**PRIVATE PLAN MODIFICATION 49**  
**HEARING REPORT**  
**VOLUME 1**  
**DRURY EAST PRECINCT**  
**FULTON HOGAN LAND DEVELOPMENT LTD**

**Reporting officer, David Mead, Planner**

**Figure 9: Possible changes to proposed zoning**

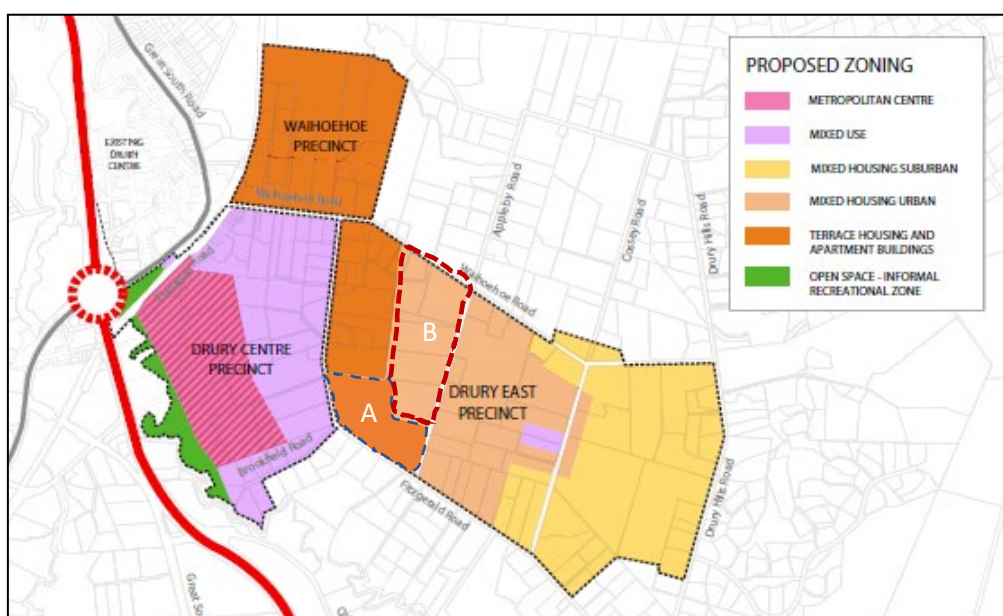
201. The extent of the THAB zone in the north-western section of the proposed precinct does need to be re-assessed in the light of the NPS-UD and AUP RPS. Policy 3 of the NPS-UD is clear in its intent that land around metropolitan centres be zoned for at least 6 storey development, while none of the qualifying matters set out in Policy 3.32 will likely apply which might suggest otherwise. The AUP RPS policy B2.2.2 (5) notes the benefits of intensification around centres. To this end, my view would be that as a minimum the sites to the south of the proposed THAB zone (which are currently proposed to be MHU), be re-identified as THAB zone (identified as area 'A' in Figure 9 below).

202. A further option would be to expand the THAB zoning into Area "B". Policies of the NPS-UD refer to land within the walkable catchment of the edge of Metropolitan Centres as being appropriate for 6 storey development. The Policy Statement does not define what is walkable, but the common rule of thumb would be a distance of between 800m and 1200m. I acknowledge that this suggested rezoning would see a larger THAB zone than show in the Drury Opākehe Structure Plan (Figure 6). Nevertheless, in my view, Area B is suitable and appropriate for a THAB zoning, particularly in light of the intent of the NPS-UD (and as is discussed in relation to submissions, I consider that this change would be within scope).

461. In relation to zoning changes in light of the AUP RPS and NPS-UD's support for intensification, my recommendation would be that the areas identified as A and B on Figure 9 in section 8.3 above are rezoned from MHU to THAB. The area identified is likely to be within the walkable catchment of the train station and will be proximate to the edge of the metropolitan centre. The greenfields nature of the site means that steps should be taken to secure capacity.
462. Auckland Council's submission relating to Business – Light Industrial zoning of any land east of the Mill Road corridor is a matter that will need to be addressed once the final future of Mill Road is known.

**Figure 11: Plan Change Boundary**

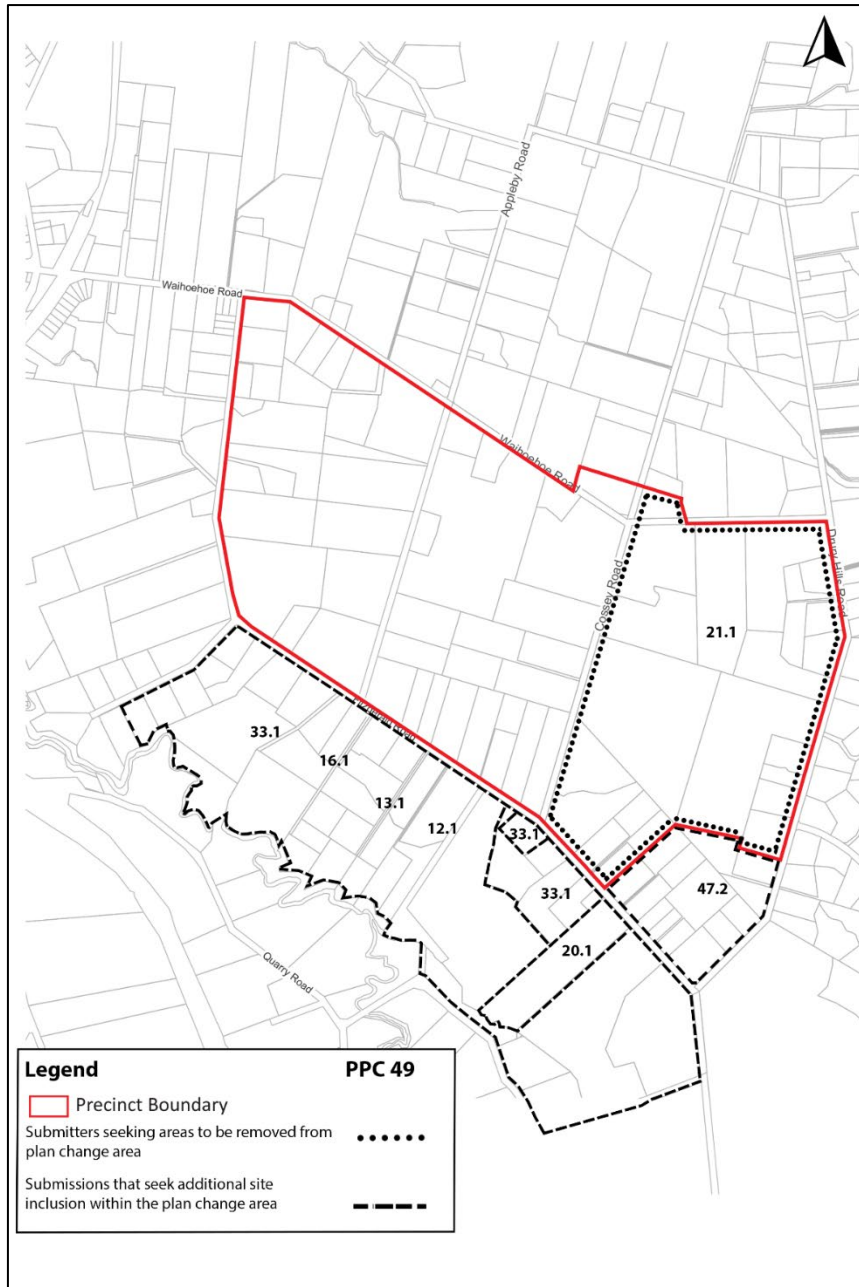
454. Most of these submissions seek to expand the area of the plan change. Areas that are sought to be brought into the plan change are shown in Figure 11 below. A submission to reduce the plan change area **[21.1]** is also outlined.

456. In my assessment there are no valid reasons to reduce the area to be rezoned, as requested by Neville Tapp [21.1]. The land subject to the plan change is zoned FUZ, with Drury Hills Road being the Rural Urban boundary.
457. The area bounded by Drury Hills Road and Fitzgerald Road (submission 47.2 in Figure 11) was excluded on the basis of the uncertainty over the Mill Road corridor and resulting alignment. Recent announcements over the Mill Road project would suggest that Drury Hills Road and Fitzgerald Road would make a more logical boundary, but as with the other possible extensions, there is no information or analysis supporting such a move.

Figure 1 Walking catchments for Auckland Council submission

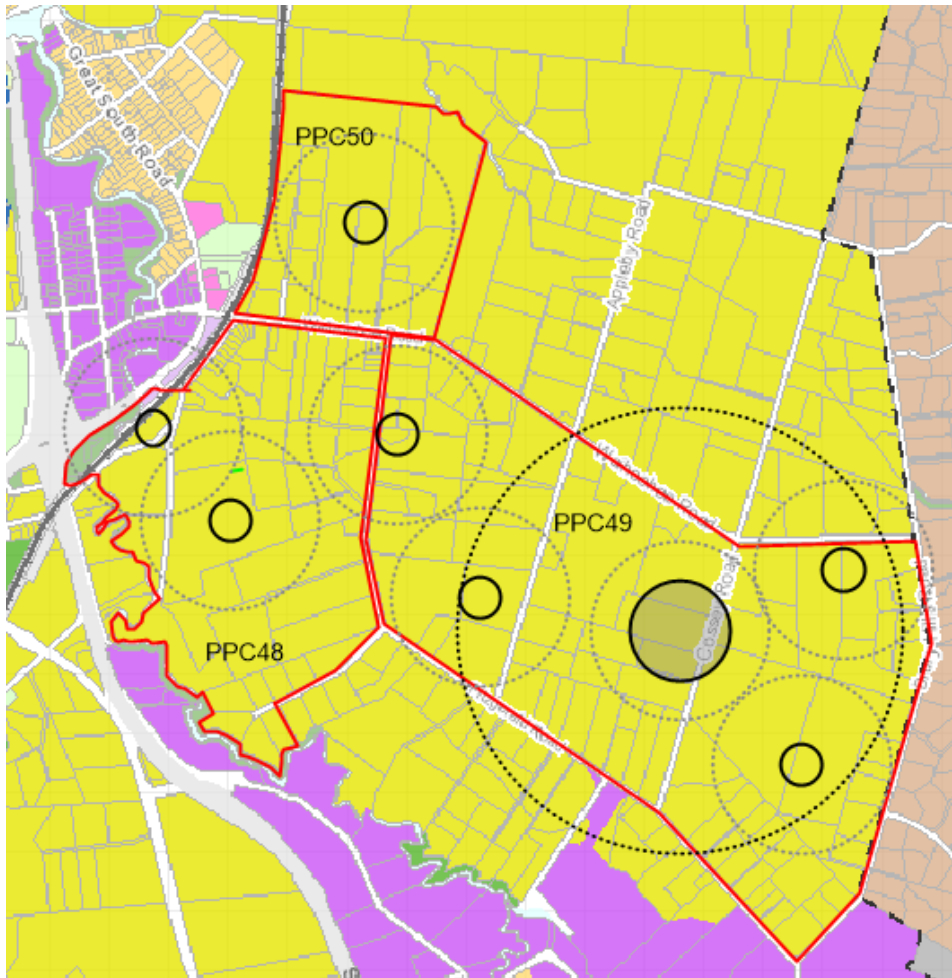
2.5 The lack of local park and suburb park open space indicated on any precinct plan maps means that there is the potential for an under provision of public recreational open space. The submission received by Auckland Council has identified an indicative location for a proposed new suburb park (5-10Ha) and four new local parks (size 0.3-0.5Ha). The Auckland Council submission is generally supported and would provide the minimum requirement for park provision for PPC 49 but would result in potentially an under provision for the other two plan change areas with regards to suburb parks. Council does not anticipate that local park land acquired for the purposes of playgrounds and kickaround areas would be provided within the flood prone land intended to be drainage reserves.

Figure 3 Proposed movement network taken from Urban Design Report

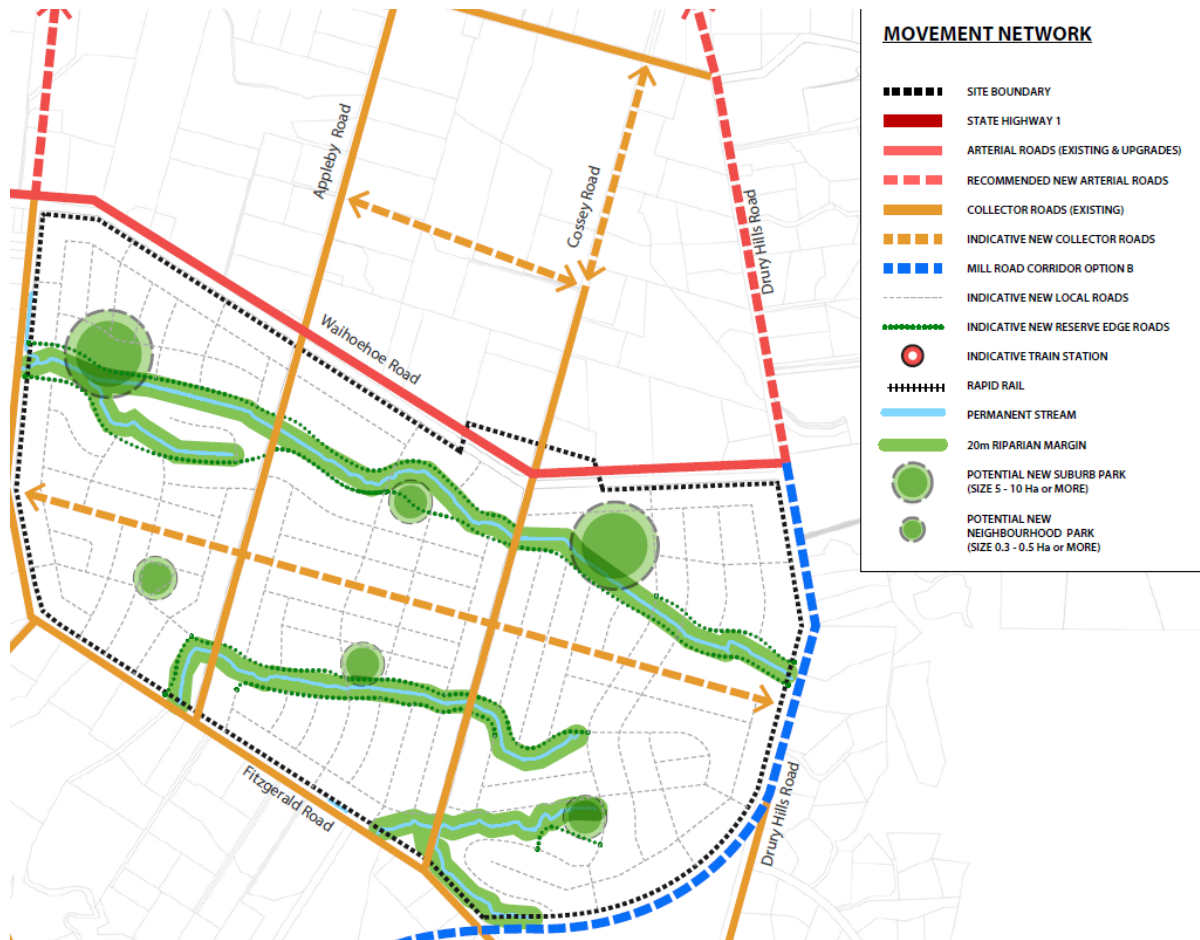
2.9 The movement network shown at Figure 15 on the urban design report prepared by Woods shows a 20m riparian margin (see figure 3). This should be clarified to being 20m either side of the permanent streams so a full width of 40m. It also shows the proposal for an indicative network of park edge roads, but doesn't appear to provide an off-road greenway cycle/pedestrian network.

**Table 4: Great South Road/Waihoehoe Road Intersection Assumptions**

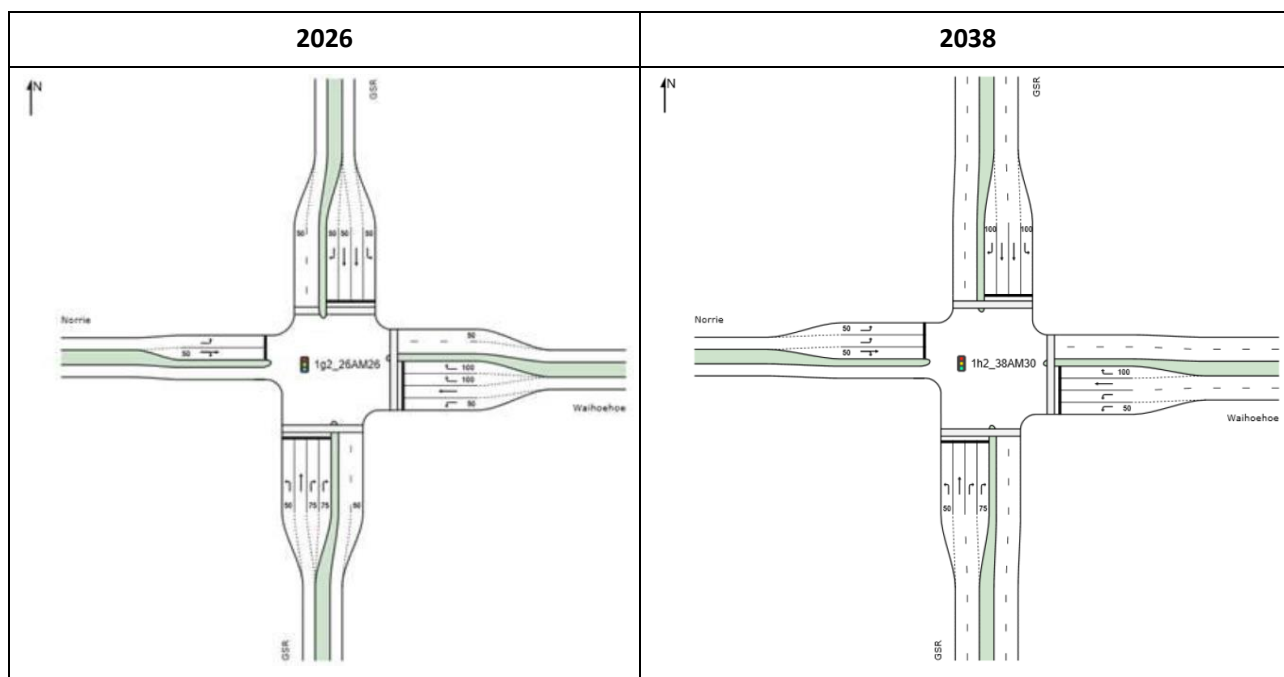
While I have concerns over the timing suggested for the intersection upgrade, I am unaware whether the upgrades put forward in the application can physically fit and provide the capacity intended within the designation that is being sought by Supporting Growth at Auckland Transport. The layouts for 2028 and 2038, as proposed by the applicant, are shown below, as included in the Transport Modelling Report. I note that neither upgrade features bus priority lanes, and they assume four approach lanes on Great South Road and Waihoehoe Road approaches and no pedestrian crossings on the Norrie Road approach. I understand that this does not reflect Auckland Transport’s design for the intersection, which I understand will include bus priority measures, only three approach lanes on the southern leg, and pedestrian/cyclist crossings on all arms of the intersection. While I appreciate that the design of the intersection is subject to further detail, the key concern relates to whether the current assumptions overestimate future capacity and therefore underestimate the potential effects and necessary mitigation.

Figure 4: Potential vehicle routes between Drury Interchange and PPC49

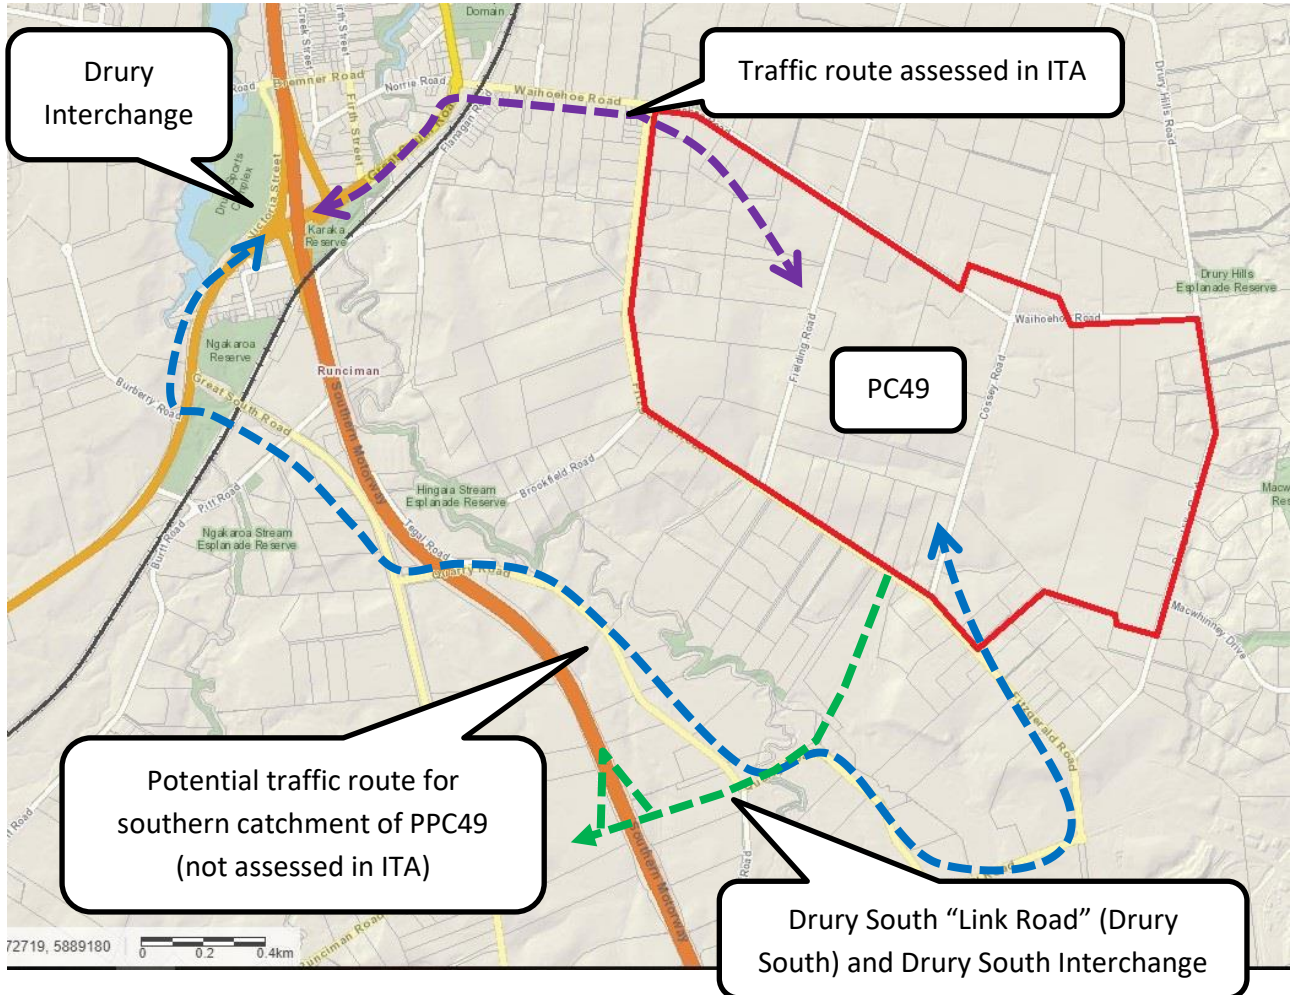
The ITA has assumed that all traffic from PPC49 will route via Waihoehoe Road/Great South Road or via the Mill Road corridor. However, until the Mill Road corridor between Waihoehoe Road and Drury South Interchange is in operation, I consider that some traffic from the southern portion of PPC49 is likely to route via Quarry Road, Great South Road, and SH22 to and from the Drury Interchange, as shown in Figure 4. The attractiveness of this route will become even higher should "Link Road" be constructed between Fitzgerald Road and Quarry Road, as required by Drury South Industrial: Precinct Plan 2, shown in Figure 5 or if performance issues occur at the Great South Road/Waihoehoe Road intersection.

**Outcome:** I recommend that a Standard be included in the provisions which requires an assessment and any mitigation works for the Quarry Road/Great South Road and Great South Road/SH22 intersections should Link Road and Drury South interchange not be constructed and operating.
